DEPARTMENT OF DEVELOPMENT SERVICES – PLANNING DIVISION
REPORT: Electrical Substation Special Permit Site Plan at 80 Seymour Street
for consideration August 24, 2021

STAFF REPORT

PROJECT: Hartford Hospital Electrical Substation
80 Seymour Street
PARCEL ID: 249-554-003
P&Z-COMM-2021-0447

TYPE: Special Permit for Site Plan Review per Section 6.13.5 for an electrical substation.

Figure 1. Site layout plan – Fuss & O’Neill 2021

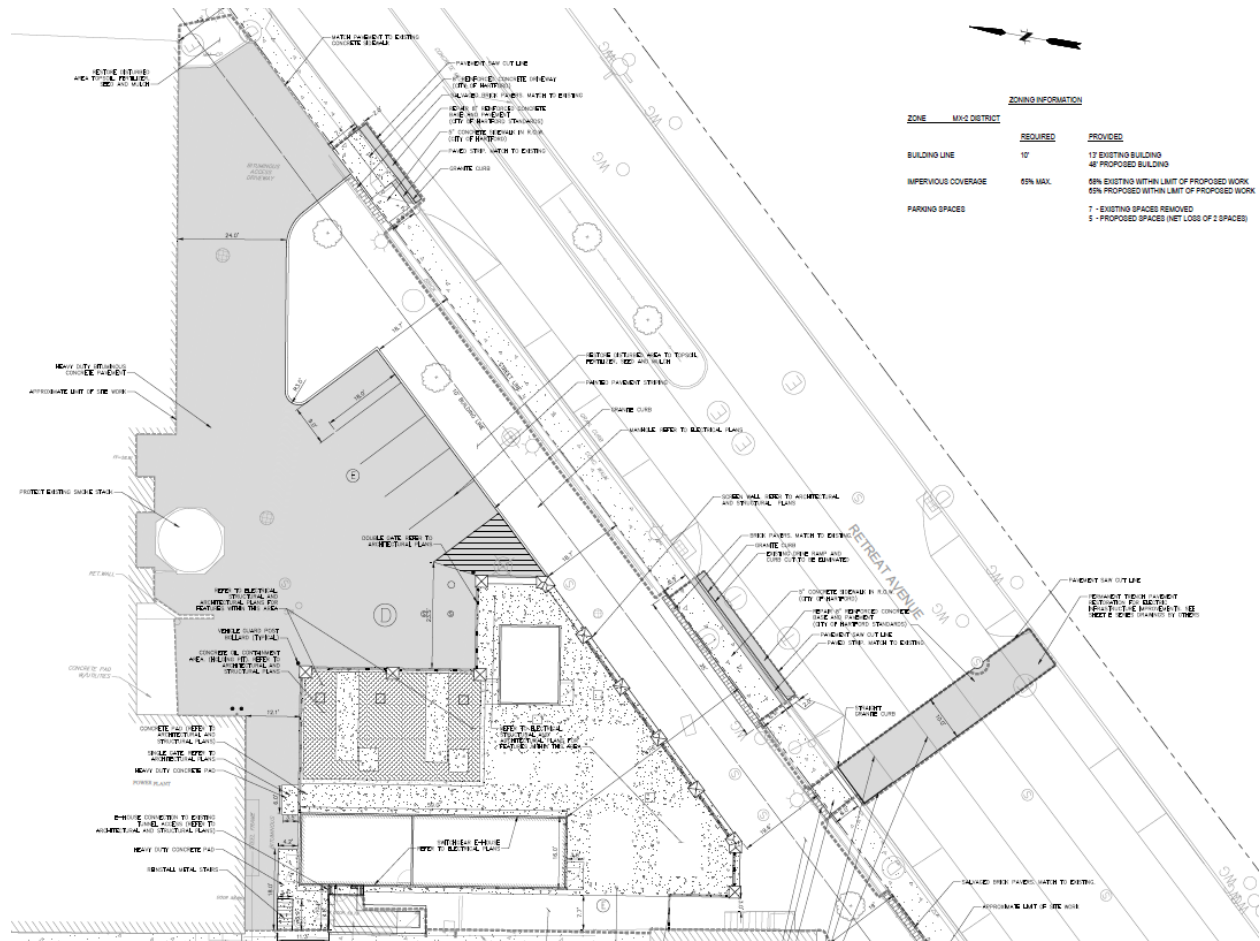
The subject construction will have a minor positive impact on pedestrian facilities. The proposed construction will close a curb-cut and restore the sidewalk to match the surrounding context, thus eliminating a potential conflict point between pedestrians and automobiles. The remaining curb cut appears to be wider than the maximum 22’ per Section 7.5.3. Smaller curb cuts are associated with slower vehicle movements and safer pedestrian conditions. The Commission should consider requiring that the curb cut be reduced at least to the regulatory maximum. This requirement is expedient because the applicant has already proposed to remove and replace the sidewalk and curbing adjacent to the south edge of the curb cut.

1. The above ground transformers shall be located within buildings sufficient to satisfy Section 3.3.8.B.(3) of the Regulations.
2. The remaining curb cut shall be reduced to the regulatory maximum width per Section 7.5 of 22'.

Figure 6. Substation plan showing proposed e-houses – Fuss & O’Neill 2021

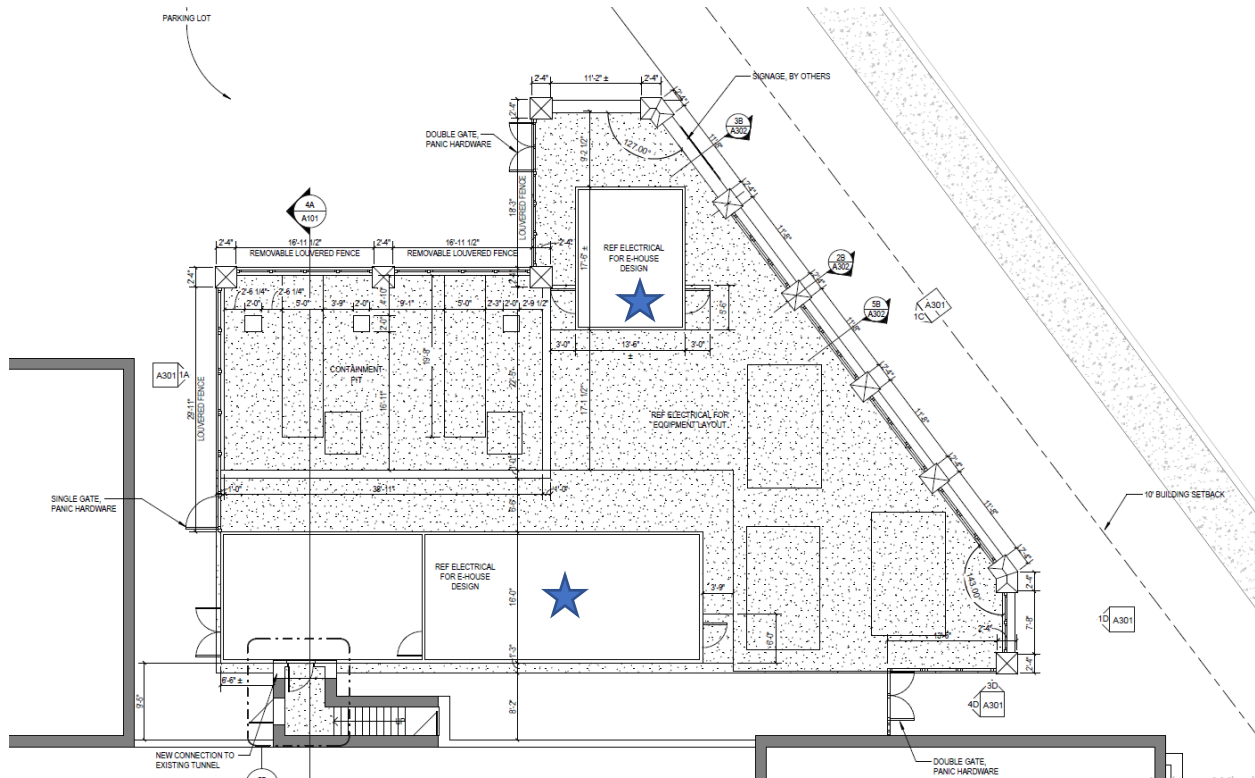
The design includes electrical transformers that are not proposed inside of a building. The design places these pad mounted transformers behind the screen wall but outside of any roofed building as required by Section 3.3.8.B. The screen wall provides significant visual protection from the public right-of-way and could be considered for purposes of this review a roofless building. However, this interpretation does not satisfy the requirement of Section 3.3.8.B. The applicant has provided "e-houses" or small buildings within the screened area to house other utility equipment. See Figure 6 below for the location of proposed e-houses. The design could be revised to include additional or expanded e-houses that could enclose the electrical transformers. The Applicant should also consider preserving the Hall-Wilson Laboratory exterior and housing the proposed transformers and utility equipment within the existing building's shell. The reuse of the Hall-Wilson Laboratory shell would preserve a historical asset while at the same time satisfying all of the requirements of Section 3.3.8.B. If the Hall-Wilson building is not large enough, a portion of the now proposed screened area could be included in the new design.
